Inspection of Automatic Sprinkler System

East London Industrial Development
Zone - Bushveld Energy

UNC.9855

Photo 2

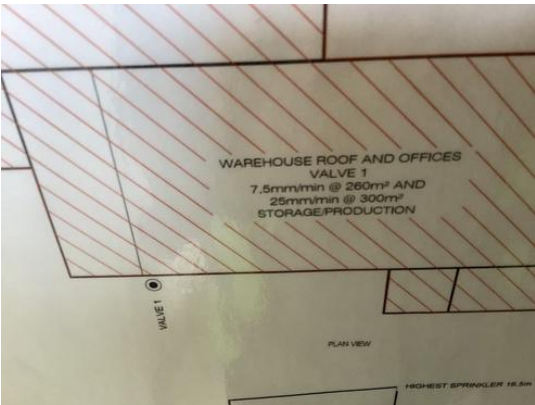
The storage section on the left of the building has a higher design density. This must be indicated on the block plan

A block plan must be provided with the following indicated thereon:

Particulars of the water supplies.

The occupancy of each building.

The hazard class of the system.

The extent of the protection.

The calculated flow and pressure requirement of the system.

A cross-section of the full height of the building or buildings indicating the height of the highest sprinkler with respect to a stated datum level.

The flows and pressures for the remote and favorable areas of operation recorded on the block plans must reflect the maximum pressure (Pmax) and the maximum flow (Qmax) respectively.
